Historic Landmarks Committee
ZOOM Online Meeting
October 14, 2021, 3:00 PM

EXHIBIT 1 - STAFF REPORT

DATE: October 14, 2021
TO: Historic Landmark Committee Members
FROM: Amy Dixon, Contract Planner
SUBJECT: AMENDED DDR 1-21 (Downtown Design Review) – 631 NE 1st Street

DECISION, CONDITIONS, FINDINGS OF FACT AND CONCLUSIONARY FINDINGS OF THE MCMINNVILLE HISTORIC LANDMARKS COMMITTEE FOR THE APPROVAL TO CHANGE THE APPROVED EXTERIOR BUILDING MATERIAL FROM STUCCO TO PAINTED CEMENTITIOUS PANELS WITH REVEAL JOINTS OF A NEW BUILDING AT 631 NE 1ST STREET WITHIN THE DOWNTOWN DESIGN AREA

Figure 3. South (Front) and North (Rear) Facing Elevations Rendering

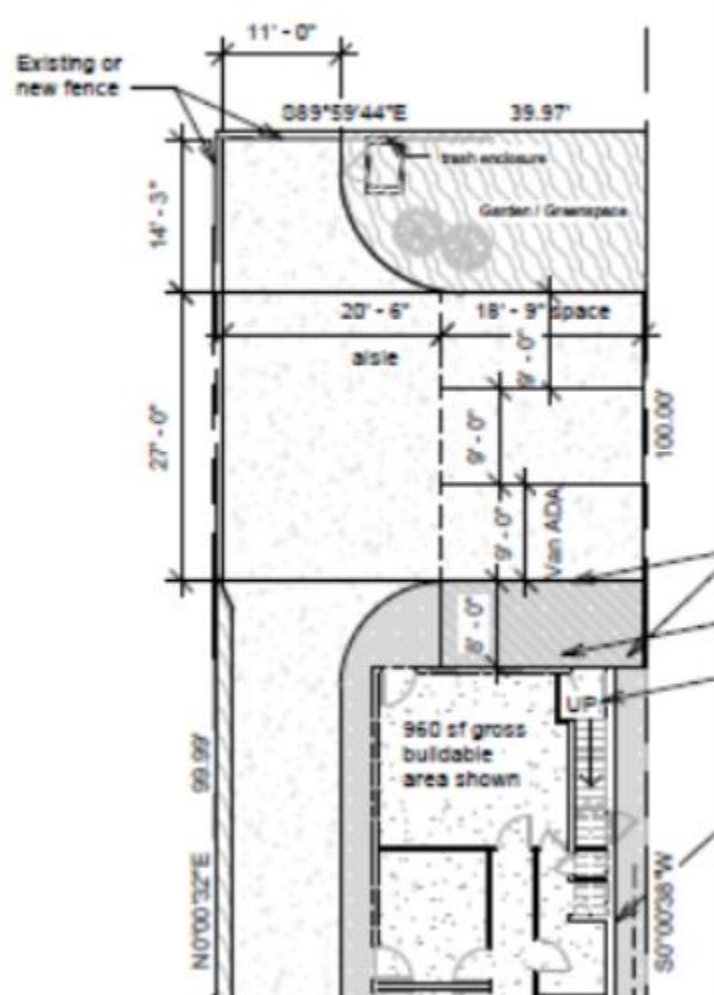
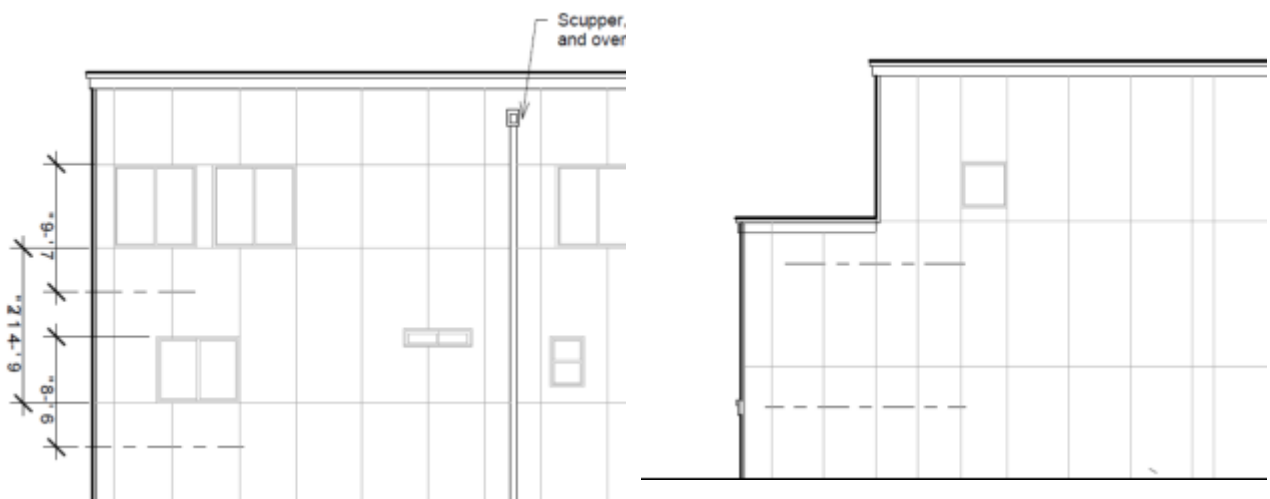
Therefore, staff is recommending that to satisfy Section 17.59.050(C)(1), a condition of approval is necessary to ensure that the proposed cementitious panels are only installed on non-public facing facades.

FINDING: SATISFIED WITH CONDITION #1. Although the applicant notes that recent projects have been approved by the HLC with a similar design material, HLC has only approved this material on non-public facing facades on historic buildings. Therefore, to satisfy Section 17.59.050(C)(1), a condition of approval is necessary to ensure that the proposed cementitious panels are only installed on non-public facing facades.

1. The painted cementitious panels with reveal joints shall be located only on non-public facing facades. The First Street façade will require a seamless joint between cementitious panels so that the reveal joint is minimized in visual appearance and prominence on the building façade.

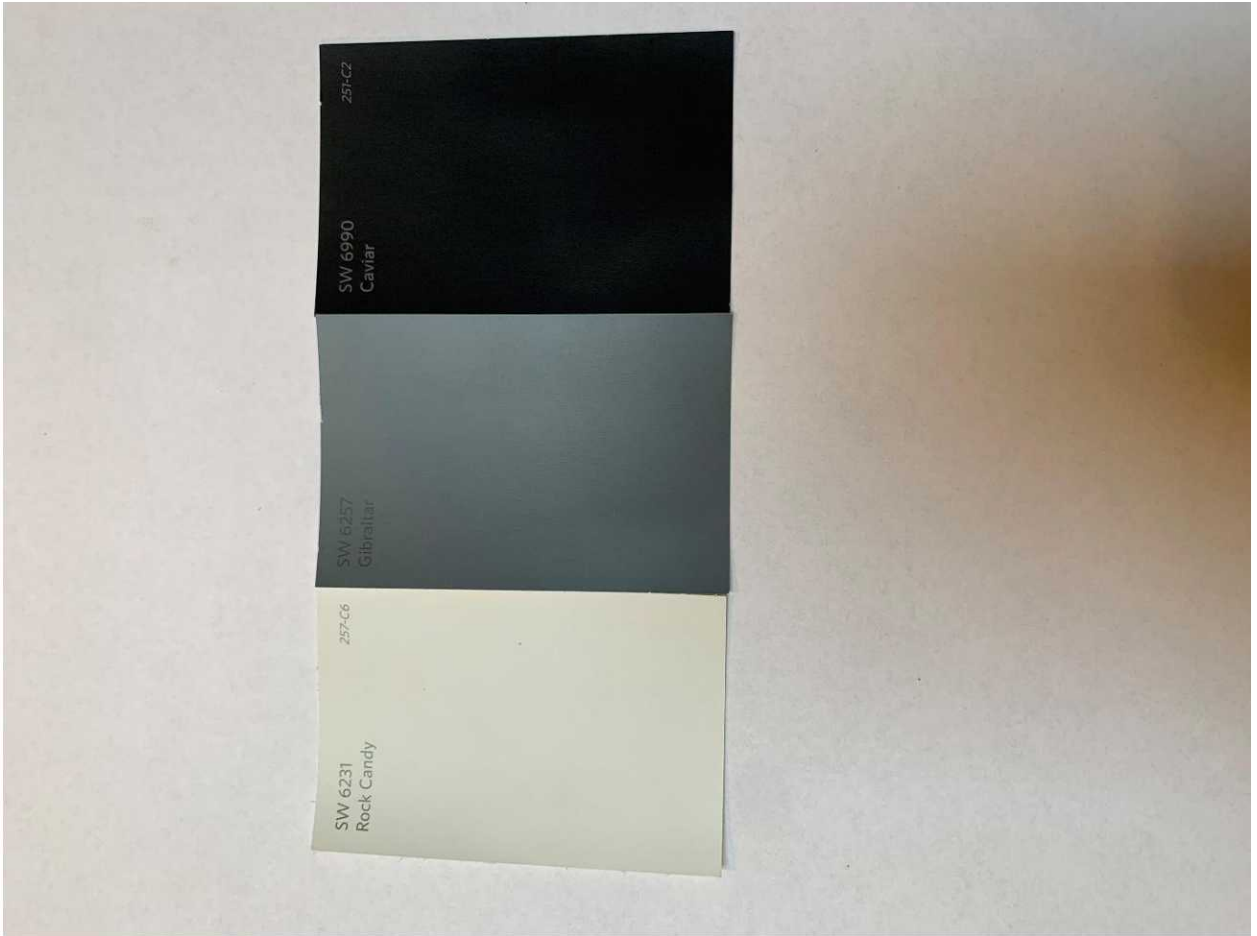
FINDING: SATISFIED. The applicant provided colors and renderings that identify exterior colors. The colors shown in the rendering consist of shades of grey, which are generally all subtle, neutral, and earth tones. Therefore, this criterion is met.
